**ADDENDUM NO. 1**  
**WILLIAMS STREET SEWER REPAIR (RFP)**  
**CONTRACT NO. W-07-002**  
**CITY OF CHATTANOOGA, TENNESSEE**

**CONTRACT #W-07-002**  
**WILLIAMS STREET SEWER REPAIR**  
**RFP PRE-SUBMITTAL MEETING MINUTES**  
**August 1, 2007**

50716  
 LINE NO. 1  
 134-A-5

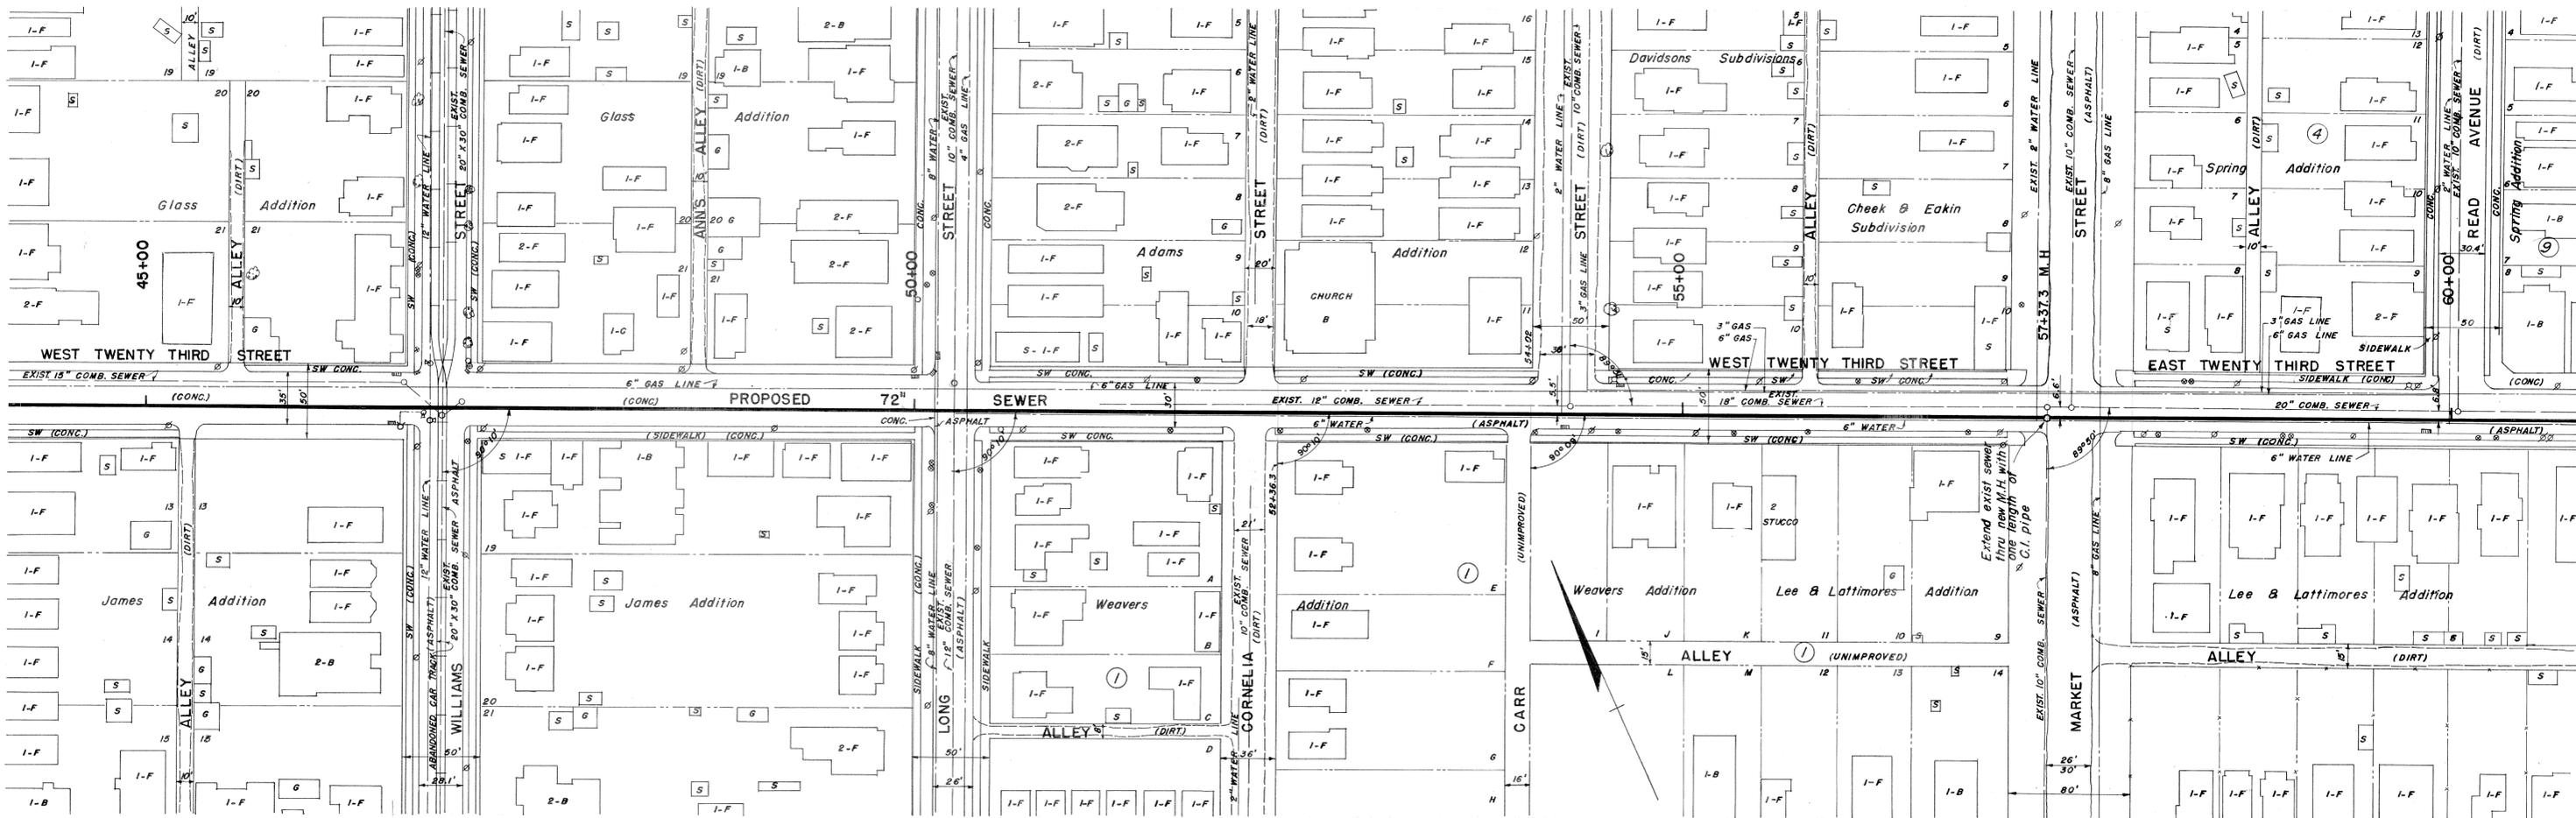
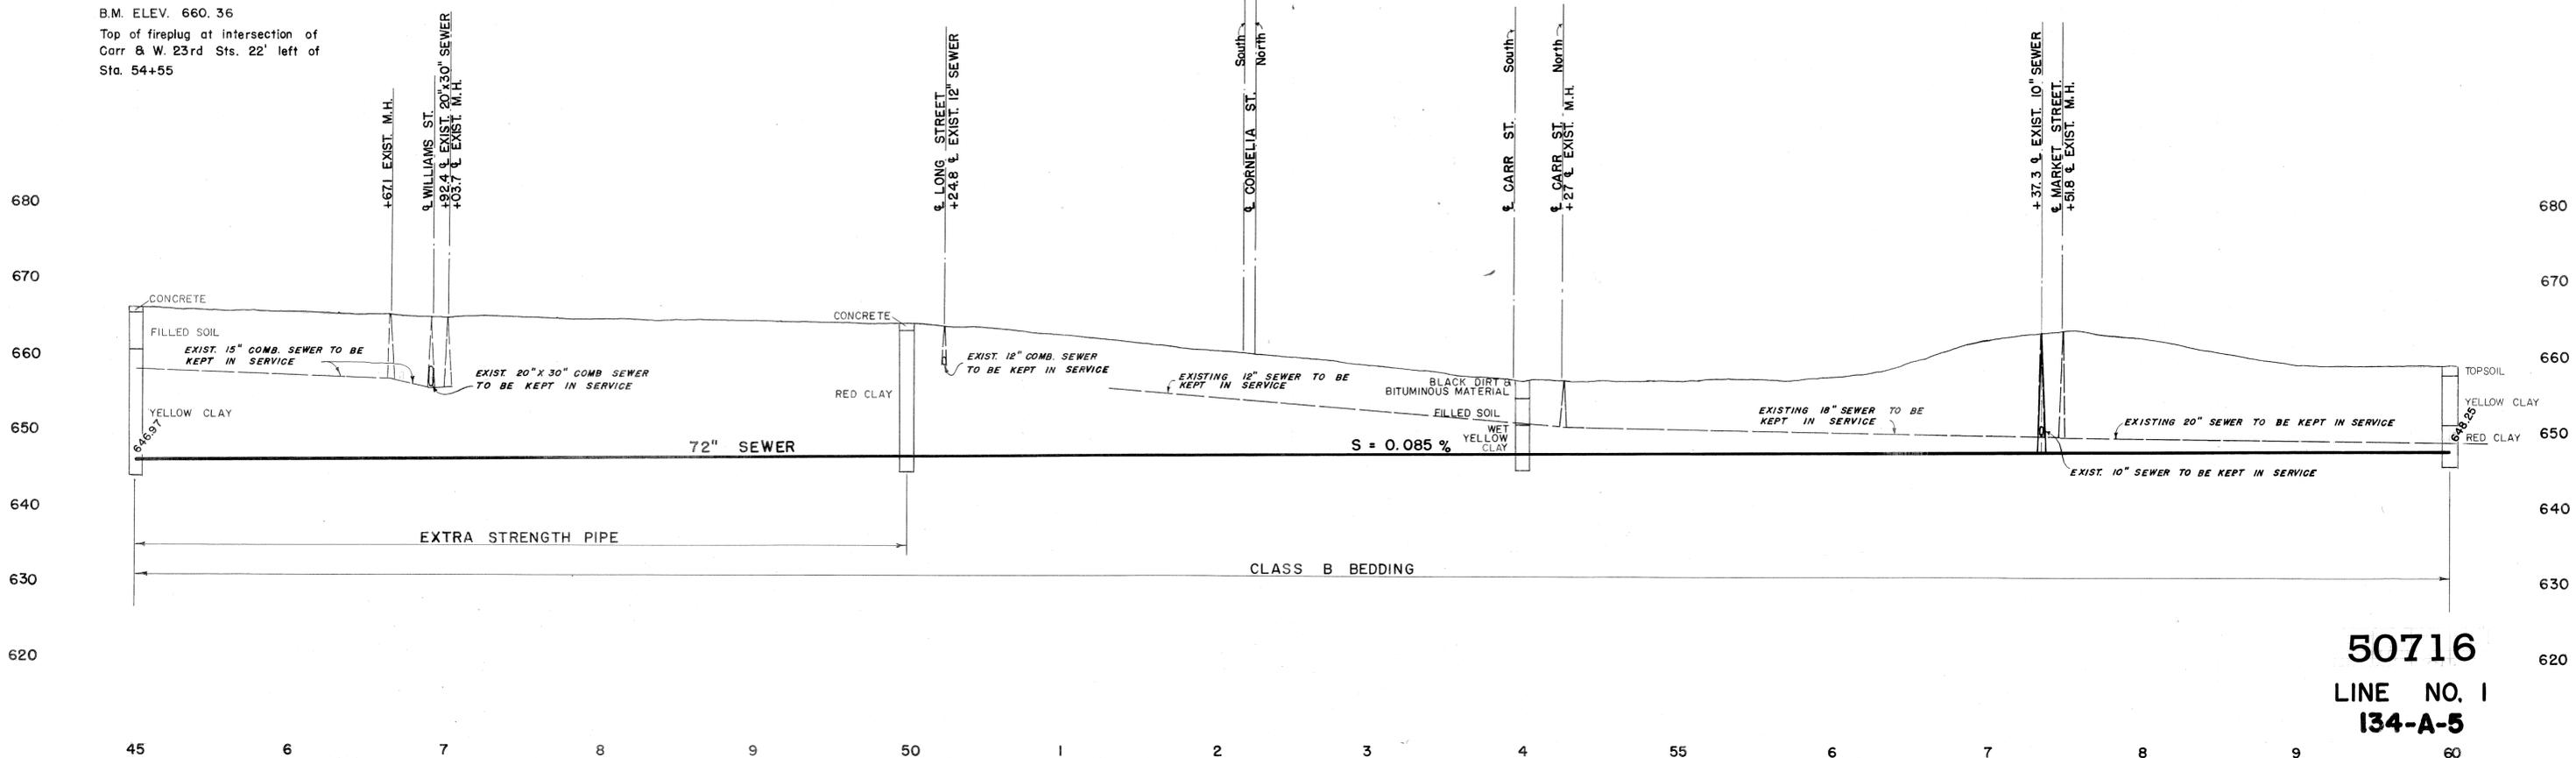
20. *Does the City have As-built information of the sewer line build back in 1955?* Yes. MF#50715 and #50716(PDF's Attached). If necessary a full size sheet may be acquired at the TIC at the DRC.
